CR 90-245

RULES in FINAL DRAFT FORM

Rule: _____ Chapters ILHR 82 and 84

Relating to: _____ Plumbing

A-82.35(8)(b) Manhole Flow Channel

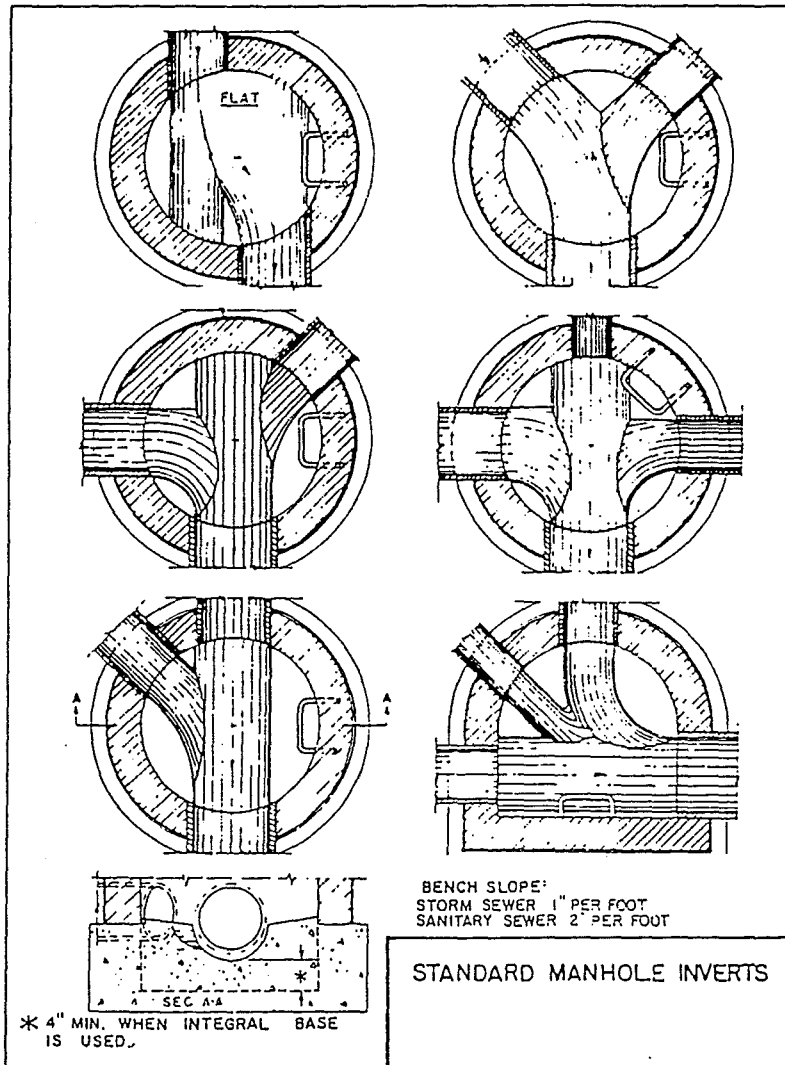
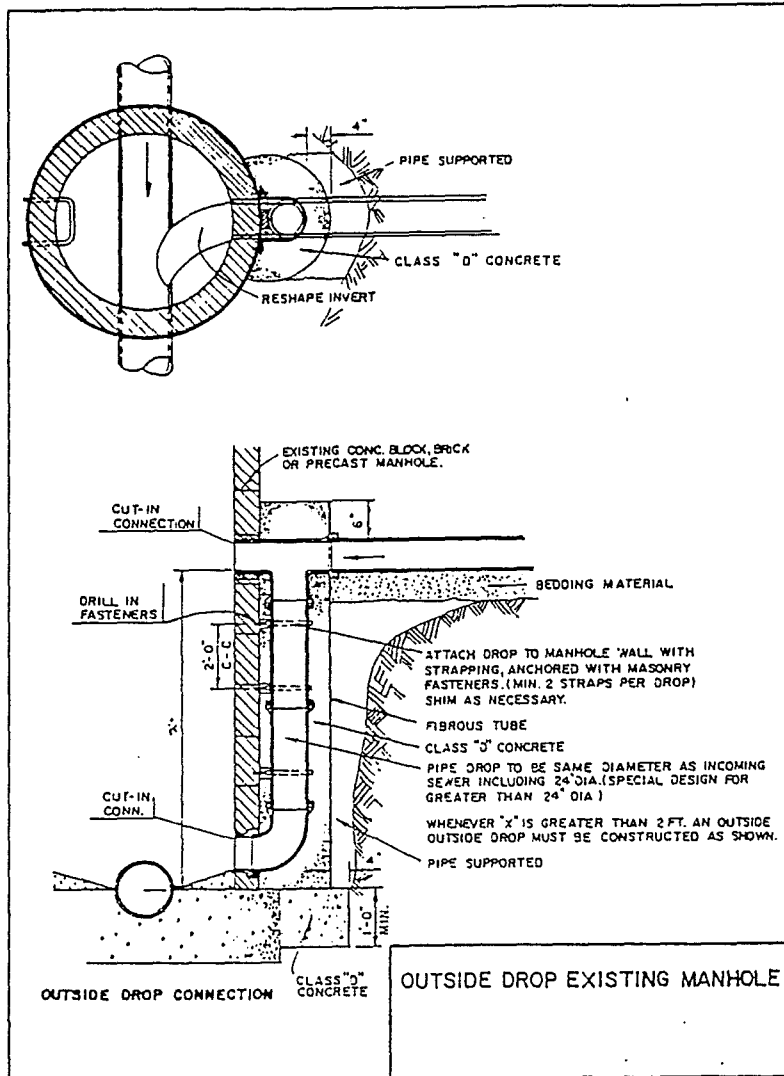
SECTION 49. Appendix A-82.35 (8) is renumbered A-82.35 (3) (1).

SECTION 50. Appendix A-82.35 (8) (b) is created to read:

(insert drawings)

A-82.35(8)(b) Outside drop manhole
